World Forum for Harmonization of Vehicle Regulations

Proposal for the 05 series of amendment to UN Regulation No. 12 (Steering mechanism)

Submitted by the Working Party on Passive Safety *

Figure 4

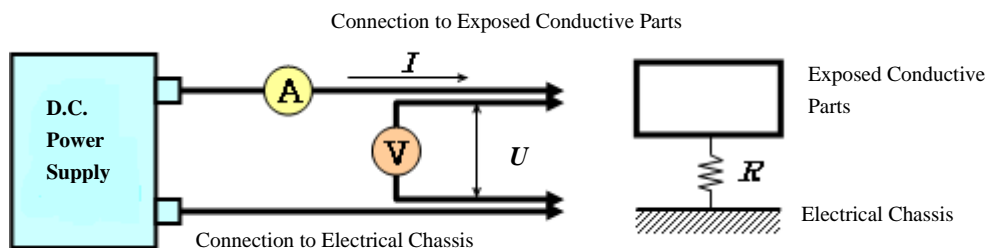
- (iii) The resistance R shall be less than 0.1Ω .
- (b) Test method using DC power supply, voltmeter and ammeter.

The DC power supply, voltmeter and ammeter are connected to the measuring points (Typically, electrical chassis and electro conductive enclosure/electrical protection barrier).

The voltage of the DC power supply is adjusted so that the current flow becomes at least 0.2 A .

The current " I " and the voltage " U " are measured.

The resistance " R " is calculated according to the following formula:

$$R = U / I$$

The resistance R shall be less than 0.1Ω .

Note: If lead wires are used for voltage and current measurement, each lead wire shall be independently connected to the electrical protection barrier/enclosure/electrical chassis. Terminal can be common for voltage measurement and current measurement.

An example of the test method using DC power supply, voltmeter and ammeter is shown below.

Figure 5
Measurement of U_1'

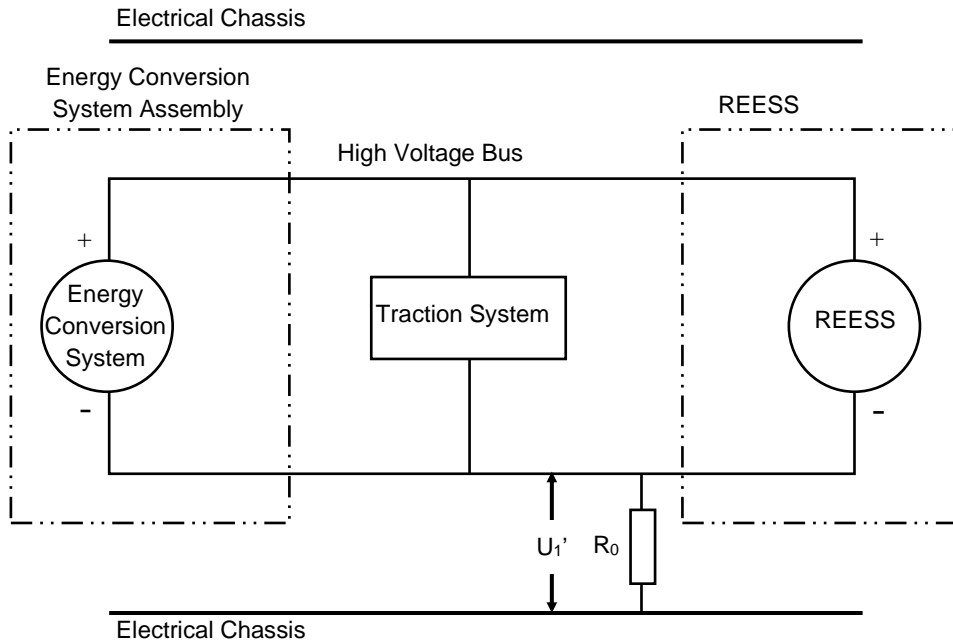
If U_1 is greater than or equal to U_2 , a standard known resistance (R_0) is inserted between the negative side of the high voltage bus and the electrical chassis.

With R_o installed, the voltage (U_1') between the negative side of the high voltage bus and the electrical chassis is measured (see Figure 5).

The electrical isolation (R_i) is calculated according to the following formula:

$$R_i = R_o * U_b * (1/U_1' - 1/U_1)$$

Figure 6
Measurement of U_2'

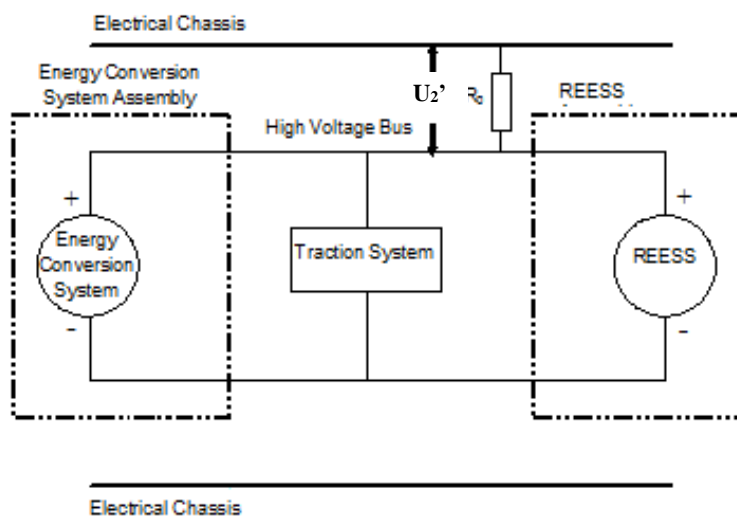
If U_2 is greater than U_1 , insert a standard known resistance (R_o) between the positive side of the high voltage bus and the electrical chassis. With R_o installed, measure the voltage (U_2') between the positive side of the high voltage bus and the electrical chassis (see Figure 6 below). The electrical isolation (R_i) is calculated according to the following formula:

$$R_i = R_o * U_b * (1/U_2' - 1/U_2)$$
